Technical Evaluation Report Salem Generating Station Storm Surge Hazard Reevaluation Review

TECHNICAL EVALUATION REPORT

STORM SURGE

Figure 15. Contour plot of PSEG SGS SWAN+ADCIRC model mesh and topography (elevations in meters; positive values below 0 ft-NAVD88)

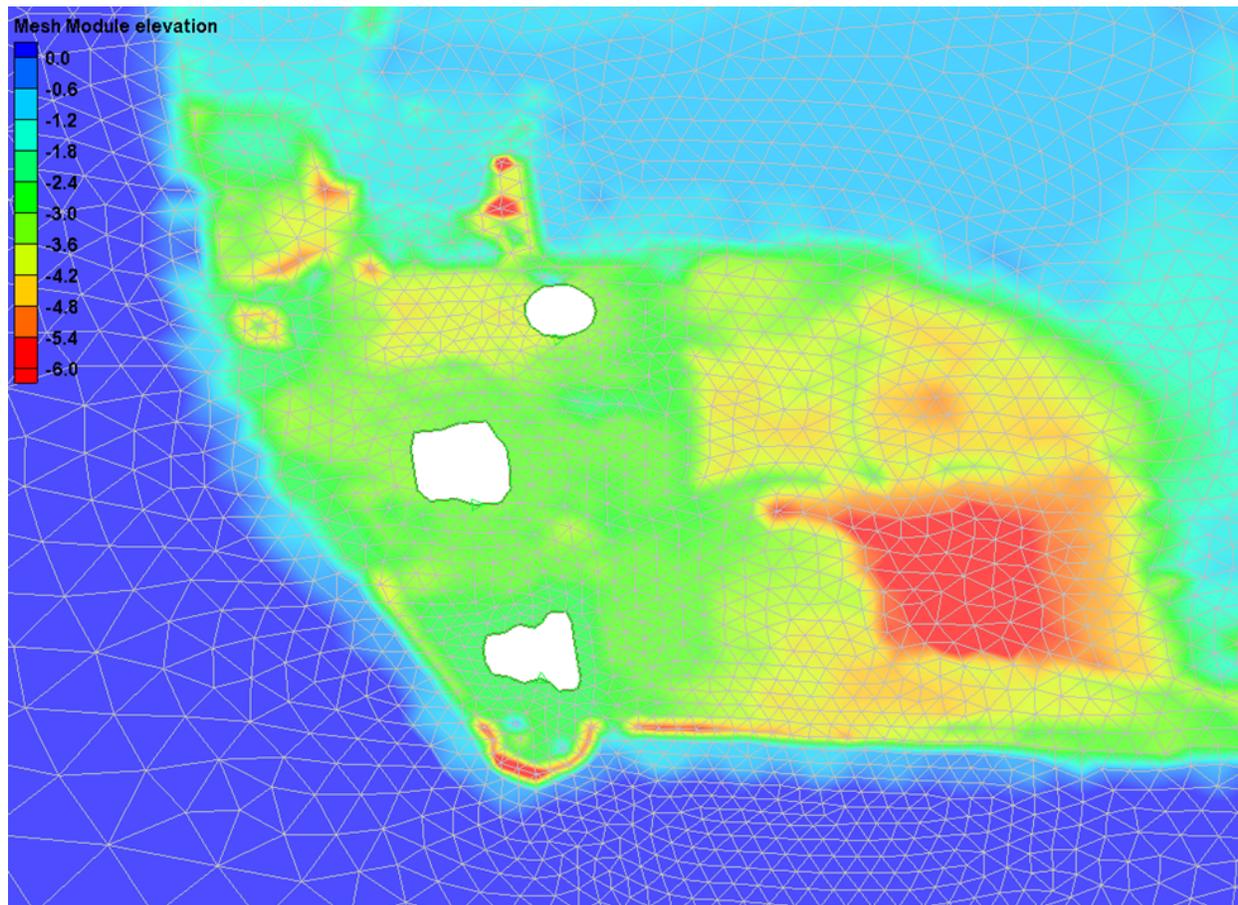
Figure 13 shows the PSEG SGS site and the infrastructure that occurs to the west and south of the auxiliary structure. Figure 15 shows a contour plot of the PSEG SGS SWAN+ADCIRC model mesh and topography with elevations in meters (positive values below 0 ft-NAVD88). Figure 15 shows that the model mesh includes topographic features on the Delaware Bay shoreline, but does not capture buildings or infrastructure near the main SGS auxiliary building or Hope Creek auxiliary building or cooling tower — identified by the white areas “cut-out” of the mesh.”
